Errata

SLG46811

CE-GP-008

Figure 2: ACMP Output during Glitching

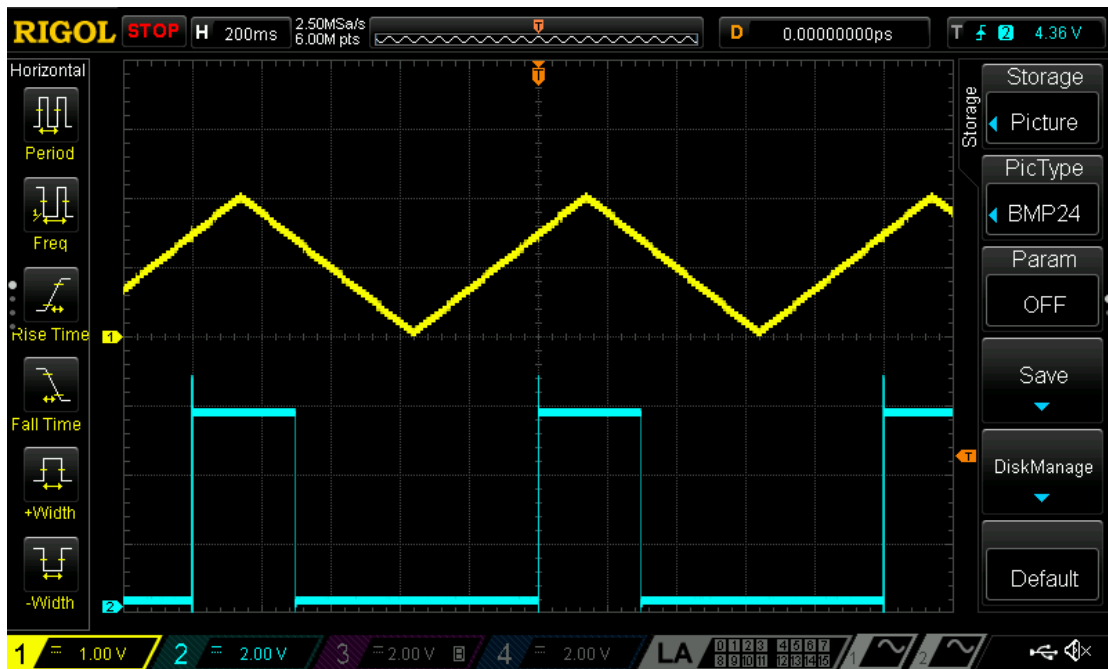
If using MS ACMP in Regular ACMP mode with 64 mV hysteresis, MS ACMP output could be glitching when MS ACMP positive input (IN+) close to the negative input (IN-). It can happen when $V_{DD} = 4.0$ V or higher and $V_{ref} = 1344$ mV or higher.

1. Waveform at $V_{ref} = 1536$ mV, hysteresis is equal to 64 mV.

1. Use the deglitch filter connected to the MS ACMP output.
2. Decrease the reference (below 1344 mV) at $IN-$ and add the $IN+$ gain to keep the needed threshold.
3. Use MS ACMP in multichannel mode.

Figure 3: Zoomed ACMP Output during Glitching

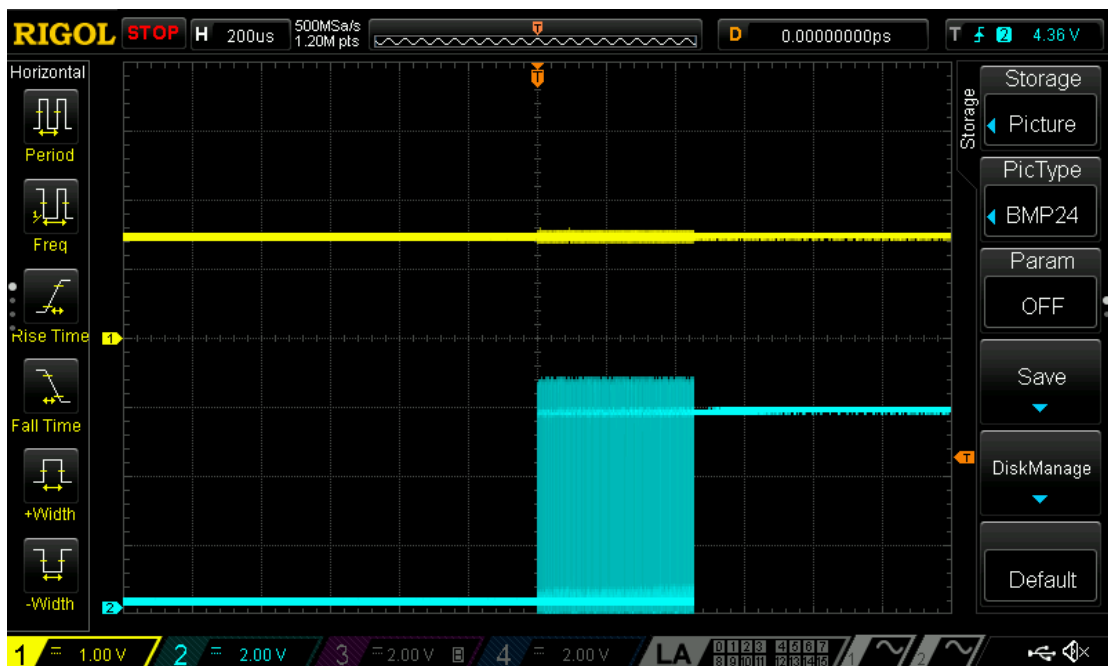
2. Waveform at $V_{ref} = 1536 \text{ mV}$, hysteresis is equal to 64 mV (zoomed rising edge).
